Inland Wetlands Agent's Report

March 9, 2021

0200921A Shane Pollock-Applicant/BLB, LLC-Owner, Louise Berry Drive, Map 19, Lot 19, RA Zone; Construction of 51 Single Family Condominium Units with activity in the upland review area.

RIP-RAP EROSION CHECK DAM

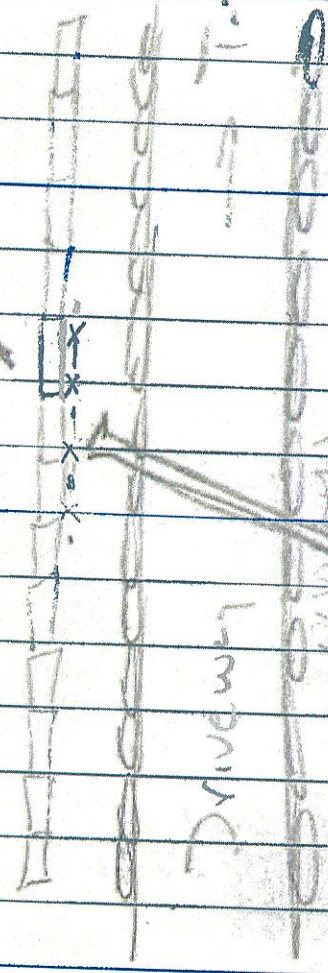
- Remove the haybale barrier, silt fence and chain link material down gradient of the 15" RCP
- Install the stone check dam as per the approved plan. This should be downstream of the new stone wall section. Recall that **intermediate** rip-rap is material 18" or less, 30-50% is between 18 and 10", 30-50% is between 10 and 6", 20-30% is between 6 and 4", 10-20% is between 4 and 2", and 0-10% is less than 2"; Modified rip-rap is less than 10", 20-50% is between 10 and 6", 30-60% is between 6 and 4", 30-40% is between 4 and 2", 10-20% is between 2 and 1", and 0-10% is less than 1". I believe that he can use some of the large native stone available on site to mix with the Intermediate size. This would increase the mass of the filter without really diminishing the capacity to pass water through. This needs to be done carefully, but once started it should continue steadily until the work is complete. The intent of the filter was to provide limited pooling during a storm event and as such the final crest should be similar in elevation to that of the driveway embankment. It should be level and extend laterally as far as necessary to meet the existing grade without hollows or channeling. The stone should be keyed into the existing stable soil several inches and should be placed in such a way that the angular faces engage neighboring stones, but not packed in such a way that water flow will be restricted or that the pore space will be blocked.

Sketch
Vegetative Crossing

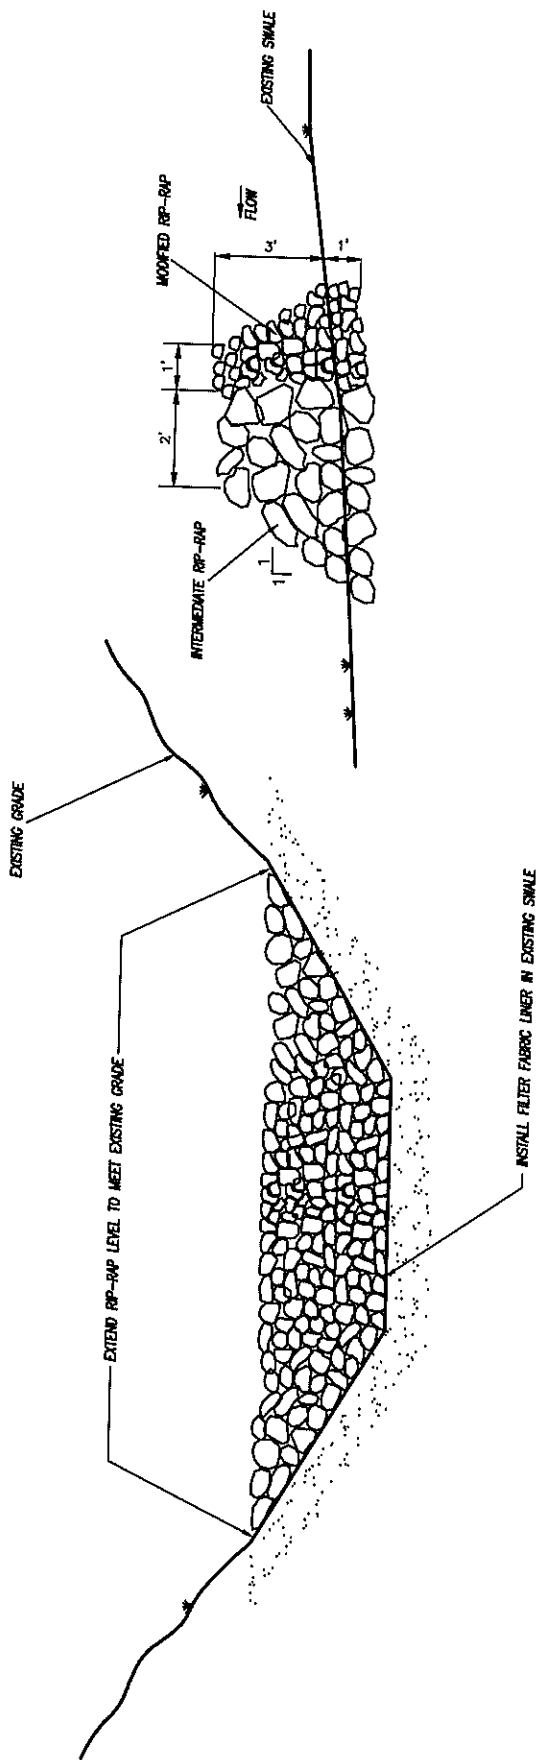
My concern with the directions would be that the first step in the "as soon as practical" is to remove the existing haybales and silt fence downgradient - this would leave little to no sedimentation controls in place until the stone check dam is constructed. It is stated once work starts it need to continue steadily until complete. No time frame is given, back in the day one of my crews would have this done in a day, not a big deal, but with a "do it yourselfer" with no experience, I am concerned.

With the rate construction progresses over there I have serious reservations that the pond would be left with little to no protection for a considerable amount of time.

Also, In the P.E.'s own words "this needs to be done carefully" "take some care in planning and executing" - will KWP be there directing Mr. Veazie ? from the impression I get from the E-mail I think they are not ? Carefully is not something we have seen to date. The written directions are fine - if given to someone that understands them.

- Remove the haybale barrier, silt fence and chain link material up gradient of the 15" RCP. The silt fence and/or haybales should not be removed along the driveway embankment but rather the end should tie back into the stone retaining system several feet from the culvert.
- Remove the haybale plug from the discharge end of the pipe

- Clean up debris, logs, and complete general 'house keeping' to remove obstacles that would restrict flow or direct water to from the natural flowpath.
- Remove the haybale mat that has been placed in the pool area.
- Hand rake and seed any disturbed areas, mulch as needed
- Stabilize driveway shoulders, rake, seed and mulch to reduce suspended solids from storm runoff.
